Drainage Assessment - Event Parking Area.

50 Peter Brock Drive, Eastern Creek,
NSW

P2108122JR02V01

Response to DPIE RFI

TYPICAL ORIFICE PLATE DETAIL
NOT TO SCALE

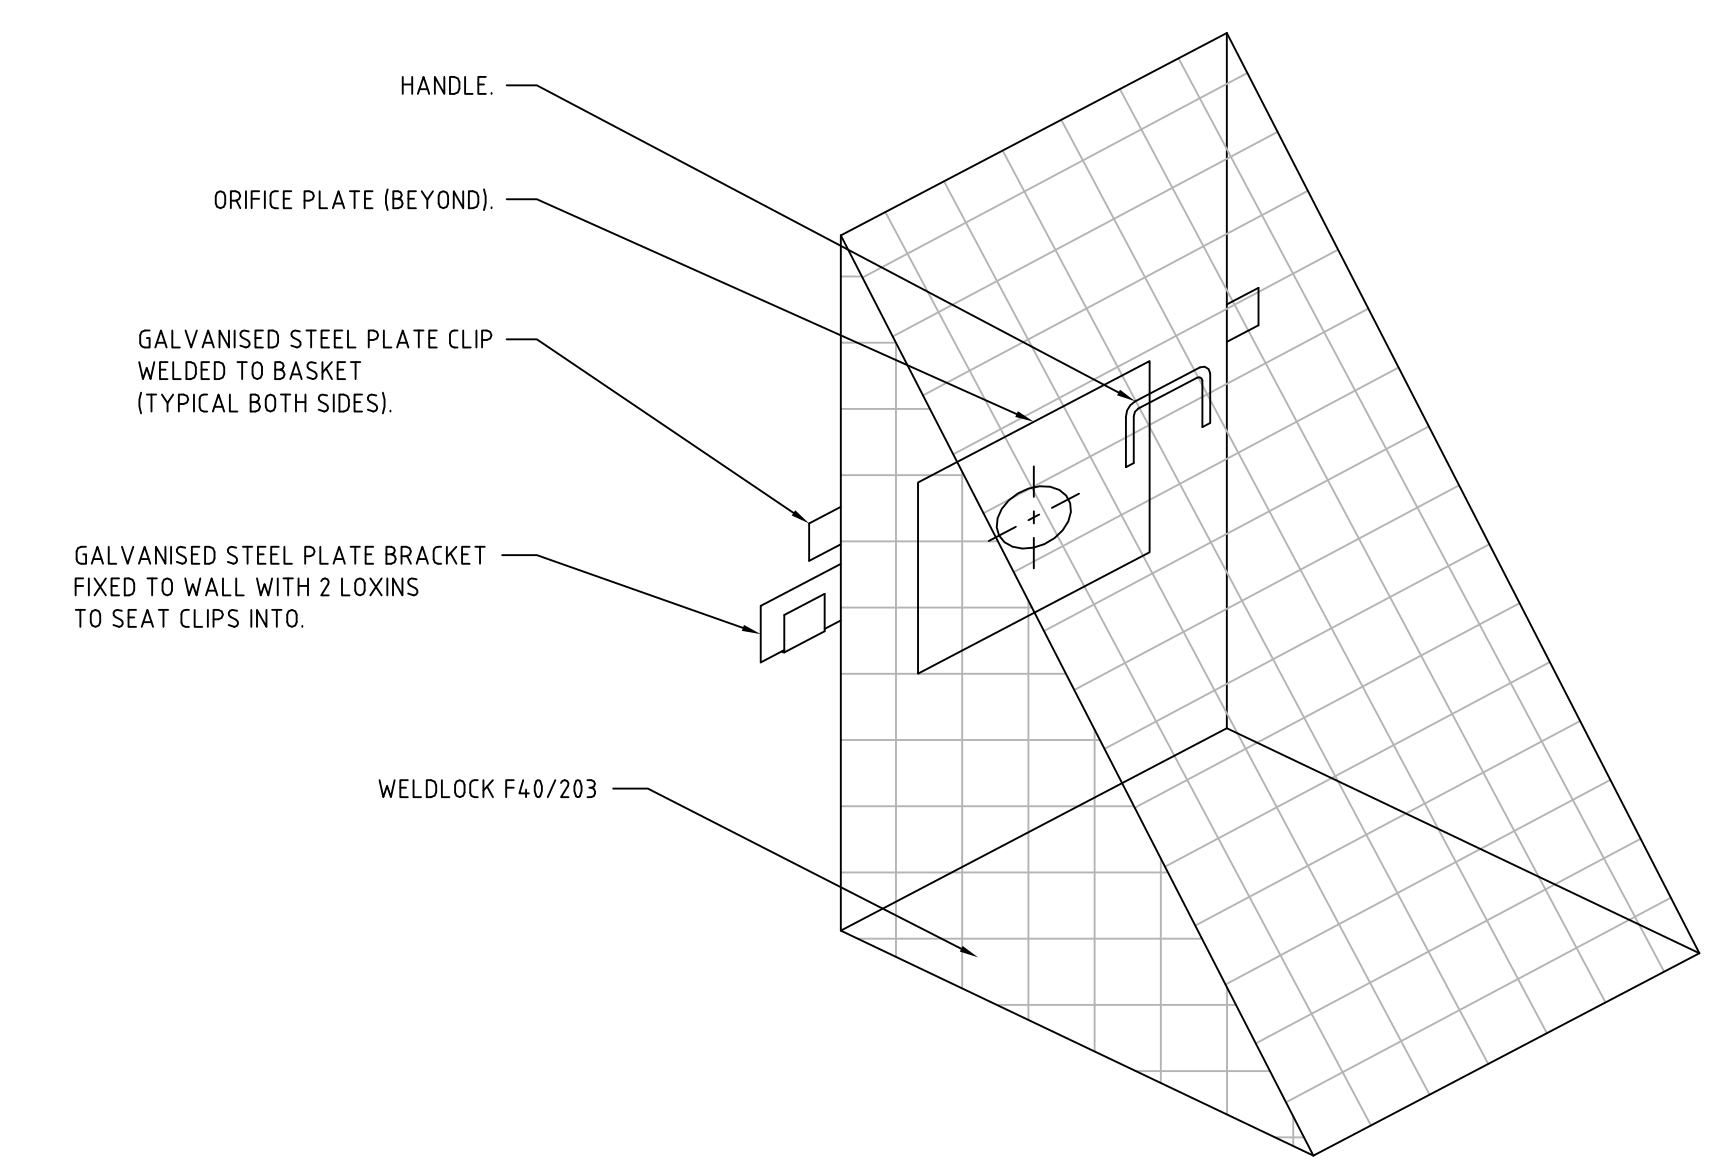
RFI Issue	Response / Comment
7.4 On-Site Detention <i>Given that gravel or bitumen sealing impacts on the previously existing impervious fraction at the subject site, impacts of increased runoff should be managed using a suitable on-site detention system designed in accordance with the Council-designated detention rate of 455 m³ per hectare or other suitable method acceptable to Council. The design of the system to be prepared by the Engineer for further consideration.</i>	OSD has been provided for the Event Parking Area in accordance with BCC's required rate of 455 m³/ha by following BCC's deemed to comply spreadsheet. Refer to Section 4 for further details.

OSD storage has been designed in accordance with BCCs deemed to comply spreadsheet tool. The site requires approximately 240 m³ for the 50% AEP storm and 365 m³ for the 1% AEP storm. Refer to Attachment C - MA planset P2108122PS01 drawing PS01-E100 for the basin location and drawing PS01-E200 for basin details.

DRAWING TITLE				
DRAINAGE DETAILS SHEET 2				
PROJECT NO.	PLANSET NO.	RELEASE NO.	DRAWING NO.	REVISION
P2108122	PS01	R02	PS01-E201	A

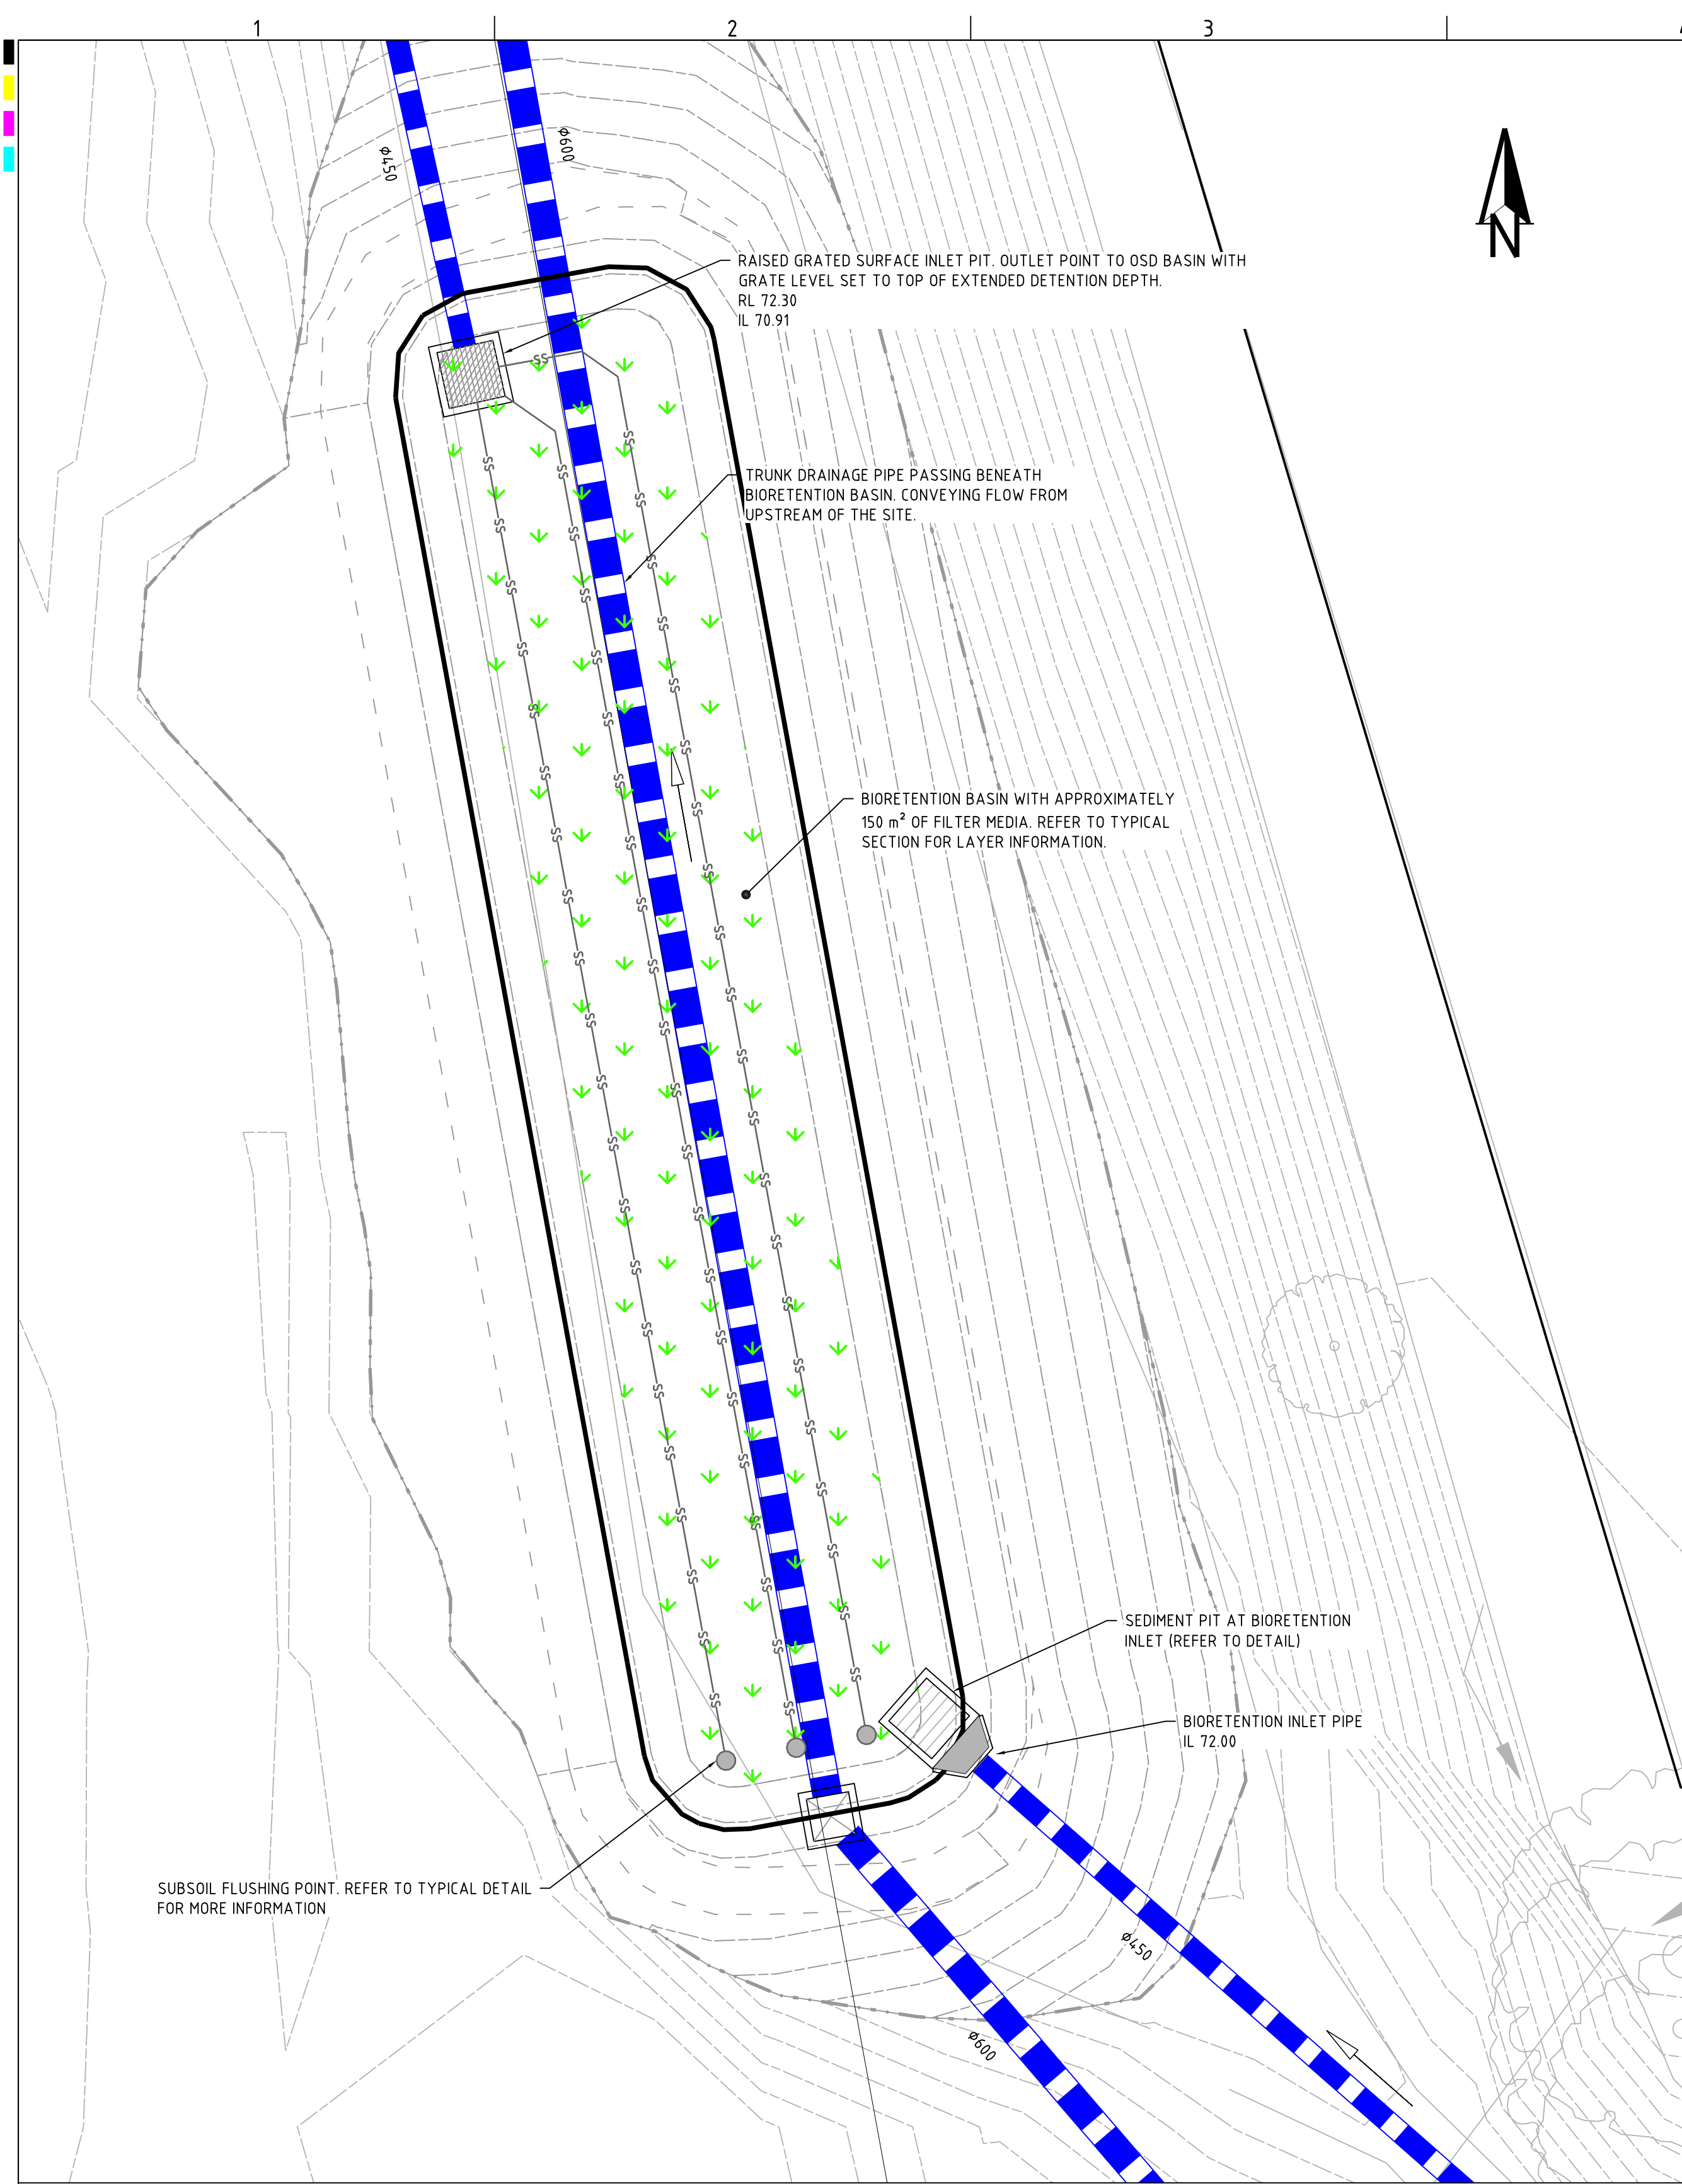
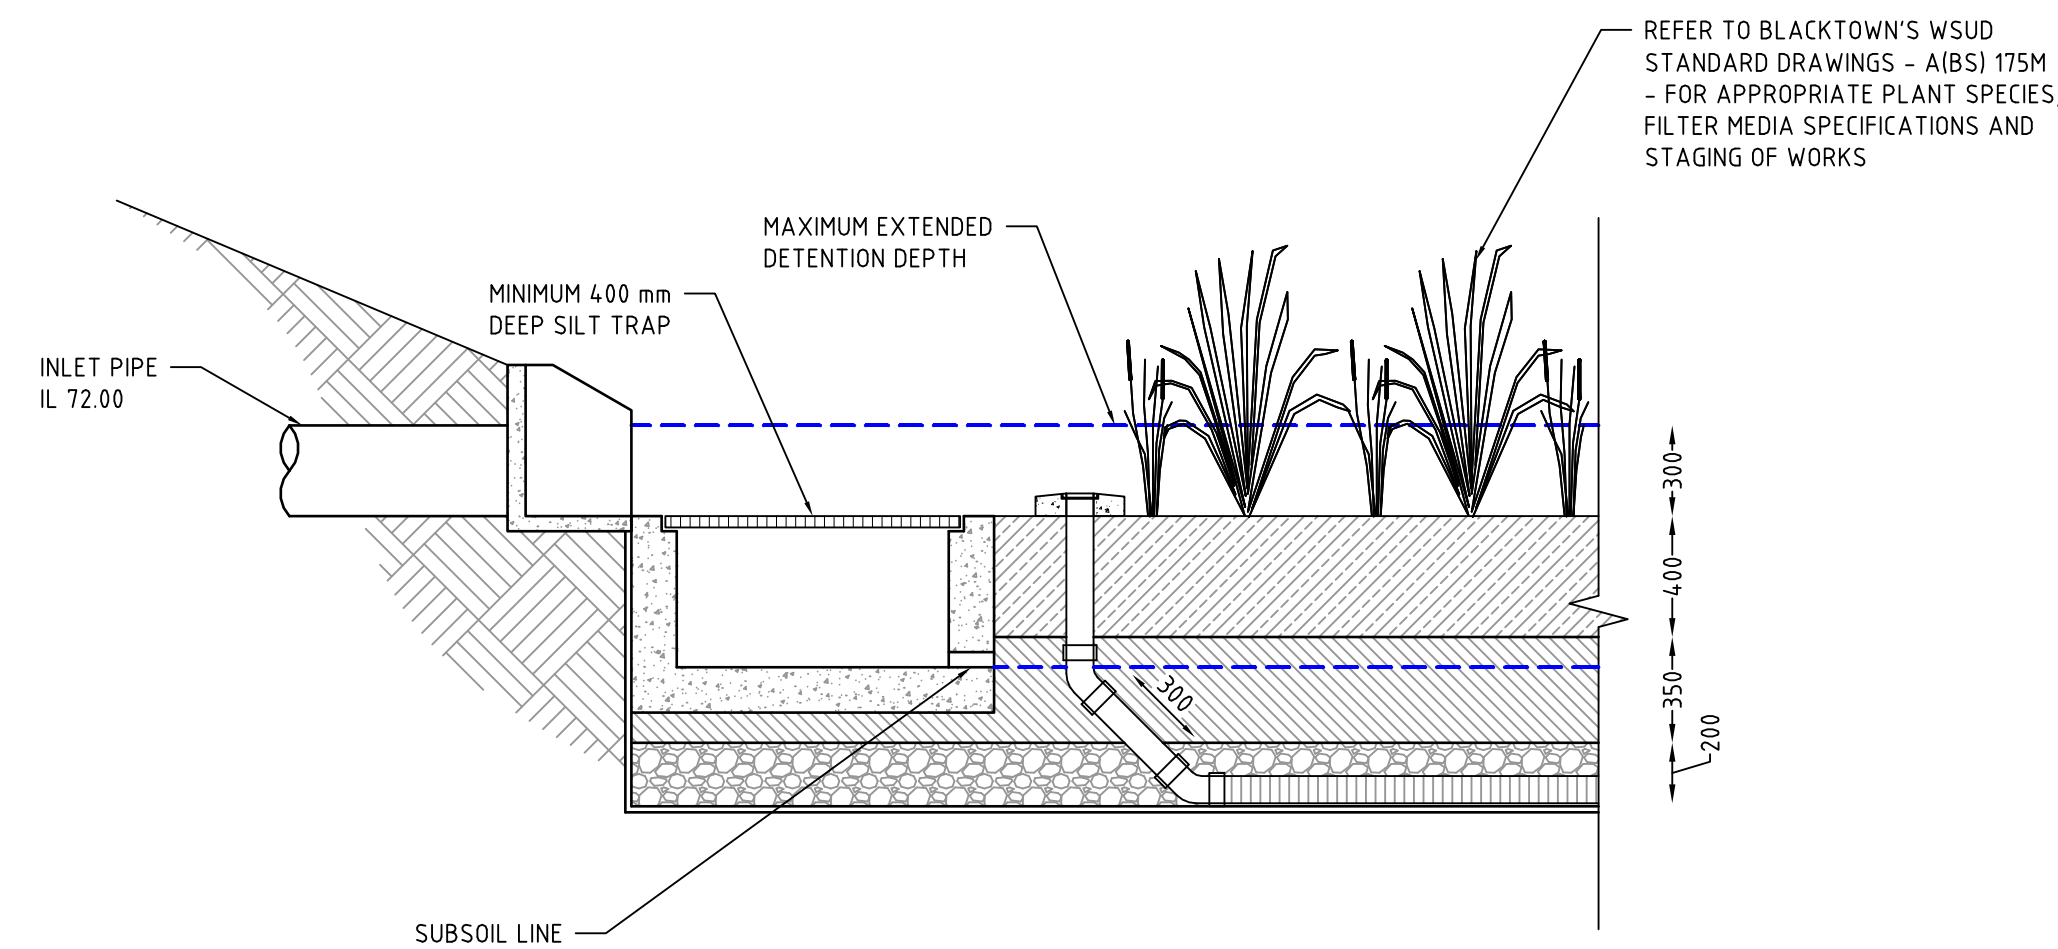
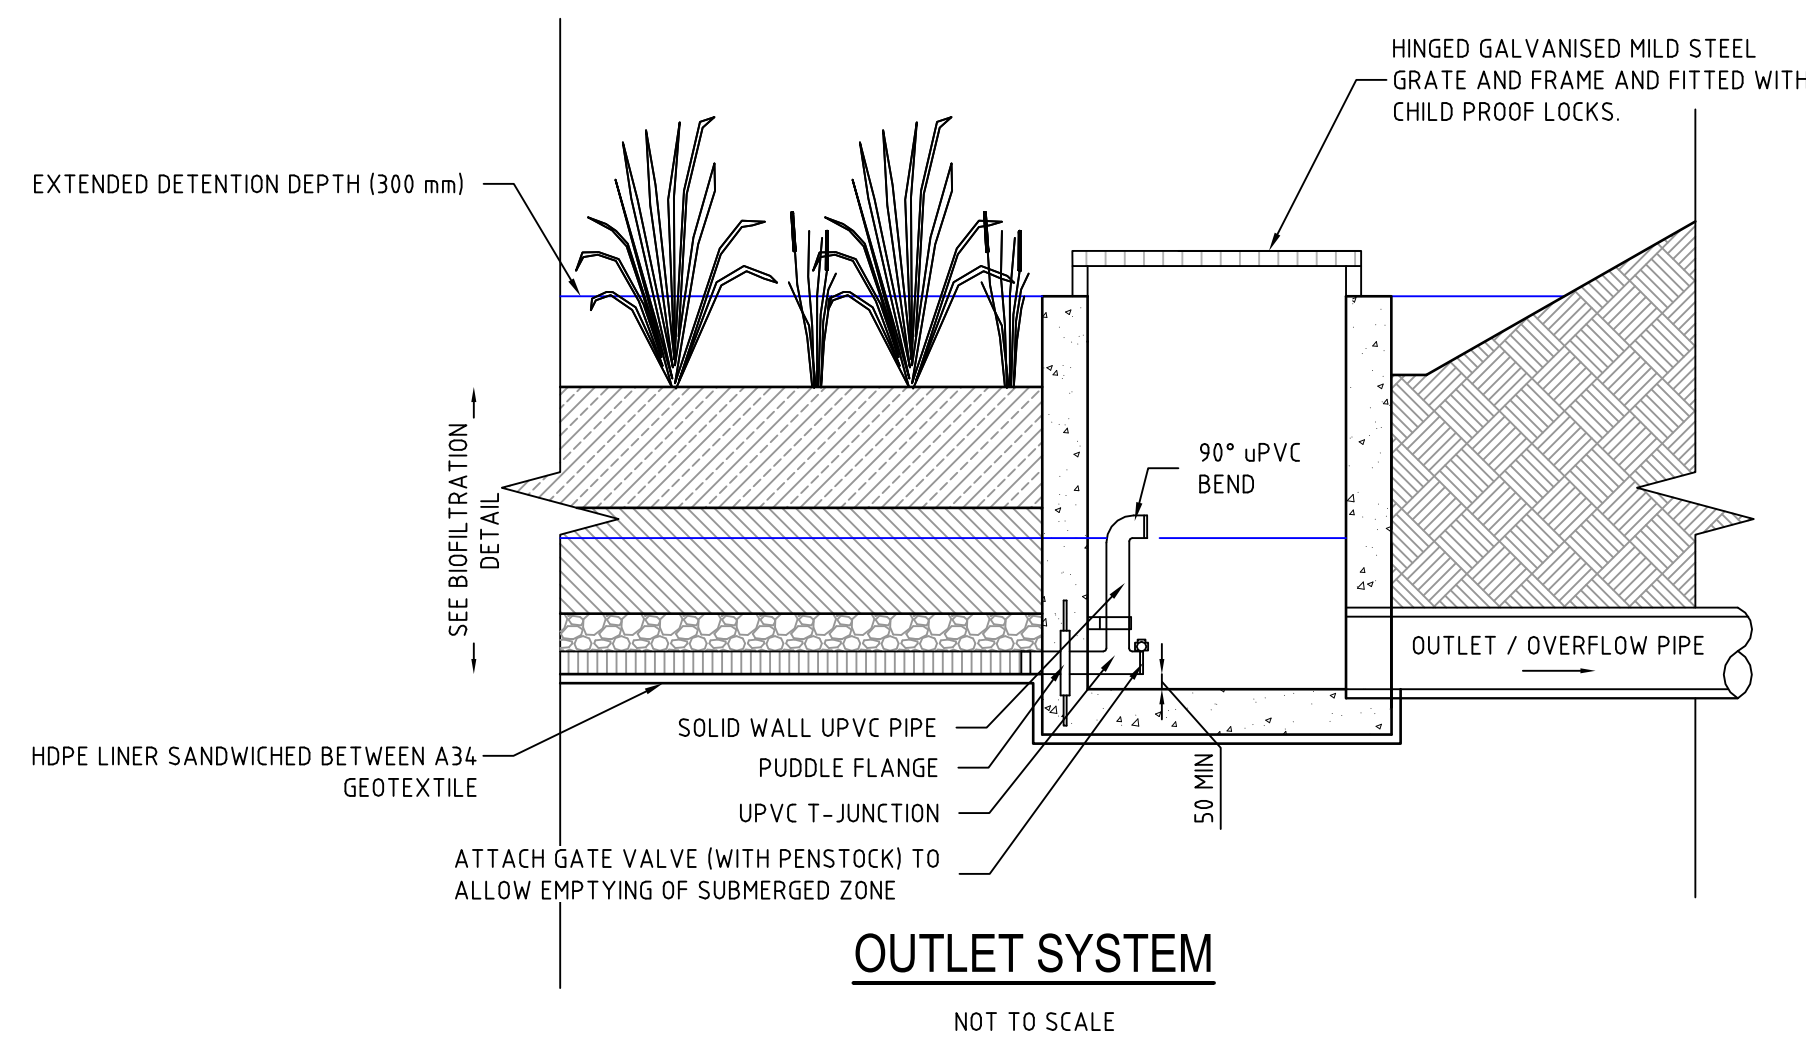
7.5 Water Quality <i>Having regard to changes in surface finish, a water quality treatment system is to be designed by the Engineer in accordance with Council's MUSIC water quality conceptualisation model and submitted for further consideration.</i>	A water quality system is included within the design of the drainage system for Event Parking Area in accordance with BCC's MUSIC guidelines to treat the pollution generated from the changes in surface finished proposed by the development. Refer to Section 2 for further details.

A bioretention basin is proposed for the site, providing tertiary treatment removing pollutants via filtration, adsorption and biological uptake. Refer to MA planset P2108122PS01 drawing PS01-E100 for the basin location and drawing PS01-E201 for basin details.
